Shell Exploration & Production

May 1, 2014

Re: Requests for Additional Information – Chukchi Sea Exploration Plan, Revision 2

- Bureau of Ocean Energy Management January 14, 2014 RFAI Responses; Shell Gulf of Mexico Inc. Chukchi Sea Exploration Plan, Revision 2

Figure 2.3-2 Barrow Man Camp Locations

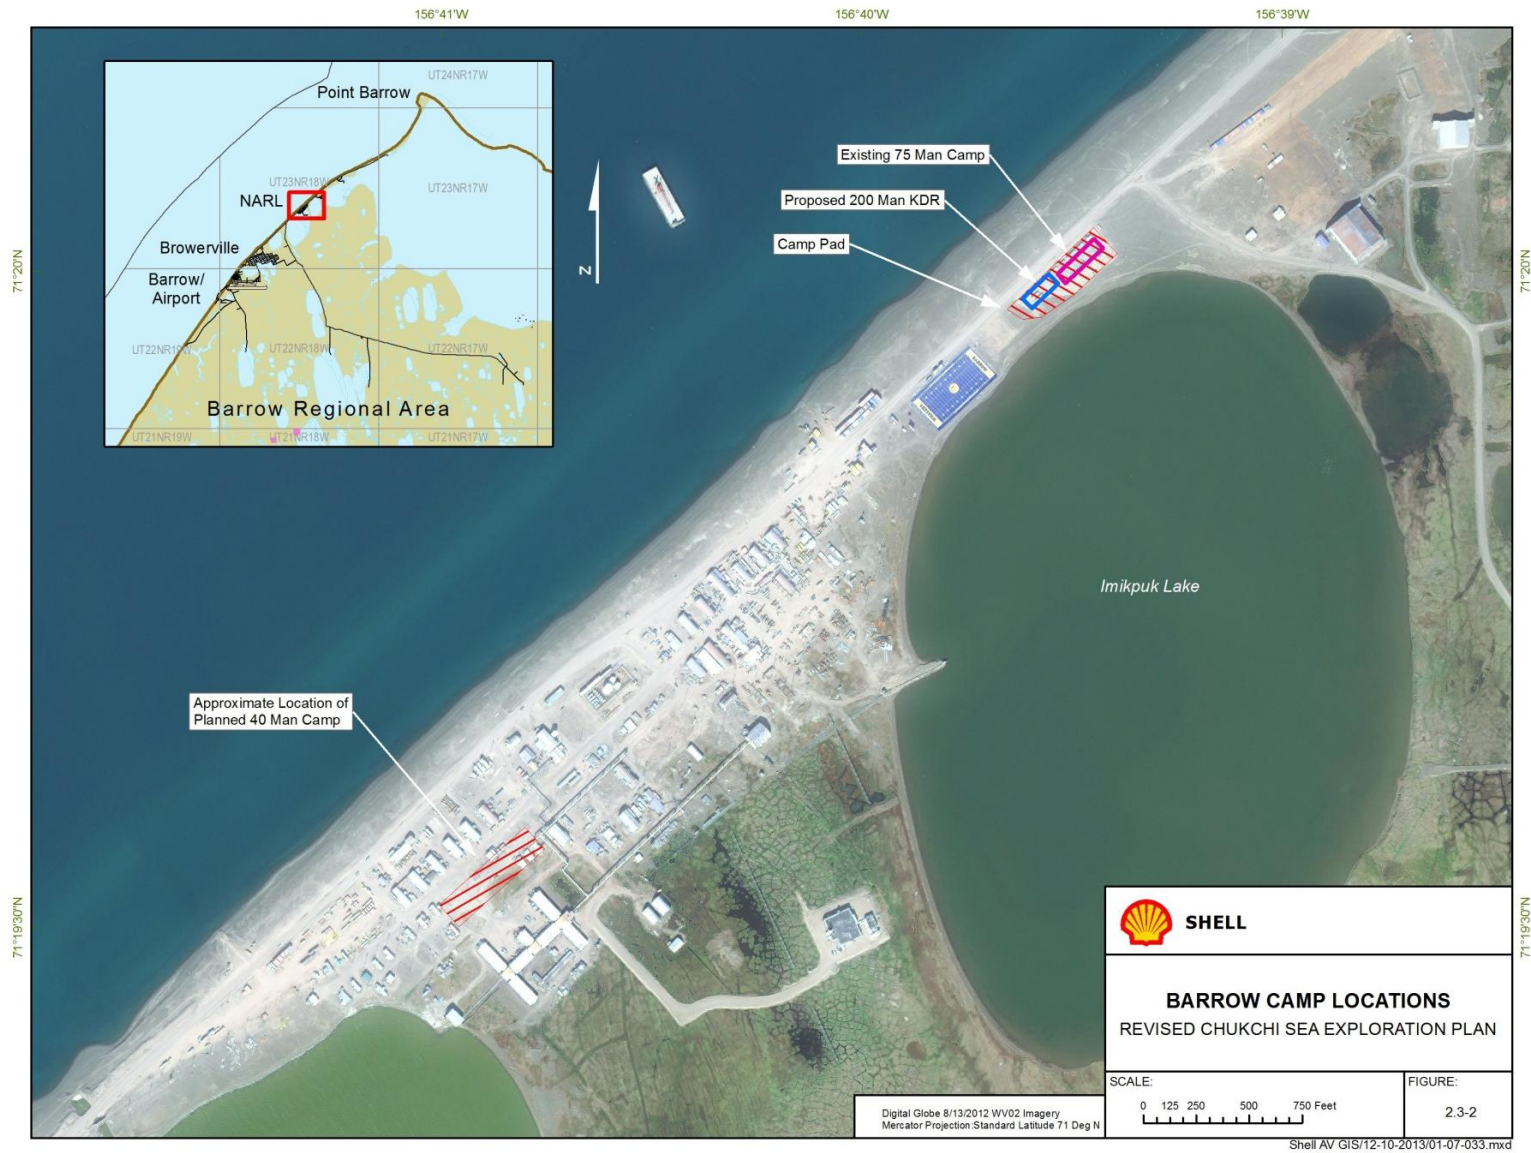
Shell proposes to increase its man camp capacity in Barrow from 75 beds to approximately 200 beds. Provide the information required by 30 CFR 550.225(a)(2); as well as any changes in existing permits that will be required for the expansion and operations of the camp. Any changes in permits and/or authorization should also be identified within Table 2.a-1; and identified and discussed within other applicable sections of EP Rev 2.

The UIC 40-person construction camp will be relocated from its existing location in Barrow to a similar sand pad constructed by the U.S. Navy in 1940's as indicated in Figure 2.3-2. The modular accommodations owned by UIC are currently unused and reside in Barrow. They would be moved to the pad and installed on through pad pilings. Permitting of this facility is not Shell's responsibility as the facilities are not Shell's; Shell will only lease the facilities once installed at the new location.

Section 2.3 of the EIA for EP revision 2 will be modified to include the above information and the following figures.
